# CITY OF ALBUQUERQUE

RE: **Lot 3 Block 9 Volcano Cliffs Unit 18 SAD 228**  
**7900 Aguila St. NW**  
**Grading and Drainage Plan**  
**Engineers Stamp Date 10/12/2020 (D10D003I3)**  
**Pad Certification Date 1/7/2021**

Based upon the information provided in your submittal received 1/8/2021, this plan is approved for Building Permit.

ENGINEER'S SEAL  10/12/20	LOT 3 BLOCK 9 UNIT 18 VC 7900 AGUILAR ST	DRAWN BY DEM
	GRADING AND DRAINAGE PLAN	DATE 10-11-20
 1608 CENTRAL AVENUE SE SUITE 201 ALBUQUERQUE, NM 87106 (505) 872-0999		LOT 3 BLOCK 9 UNIT 18 VC.DWG
		SHEET # C1
DAVID SOULE P.E. #14522		JOB #

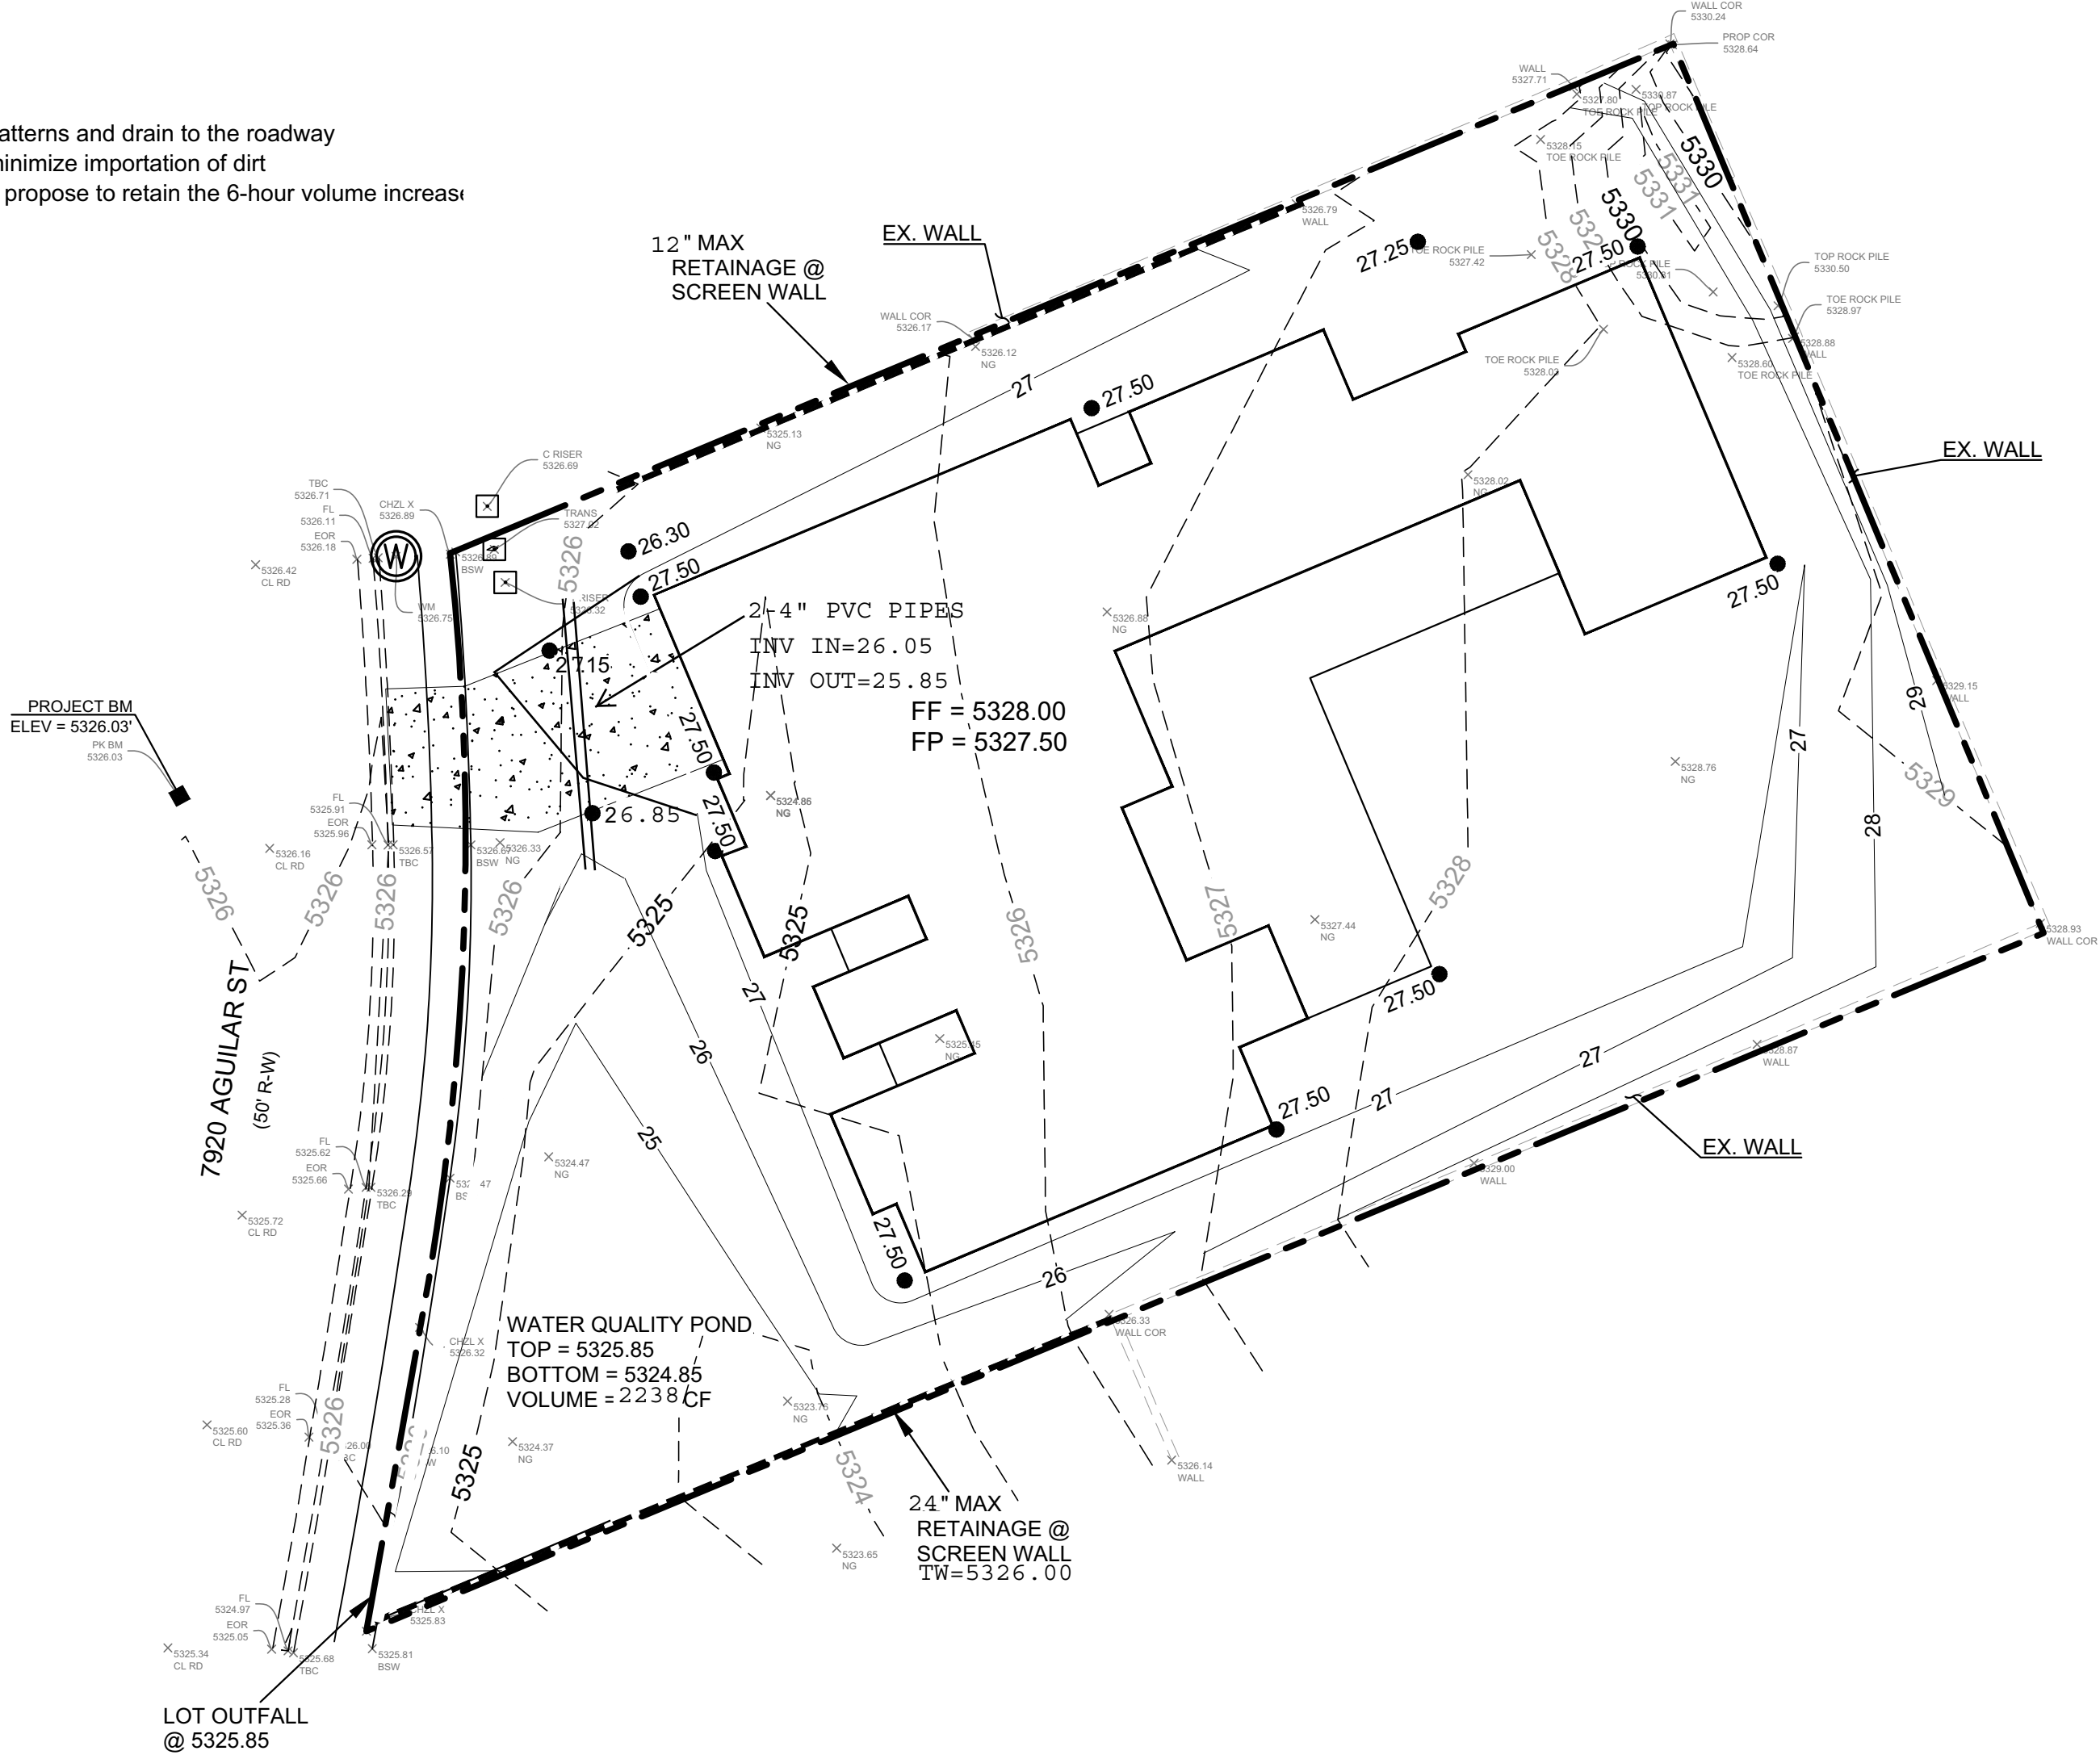
**Reiterate to the Owner/Contractor that a separate permit for a garden/retaining wall must be obtained, with the approved G&D plan and Pad Certification. Also, let the owner/contractor know that if a pool is to be added in the future the G&D plan will need to be modified showing the location of the pool and the land treatment differences.**

Prior to Certificate of Occupancy release, Engineer Certification per the DPM checklist of this plan will be required.
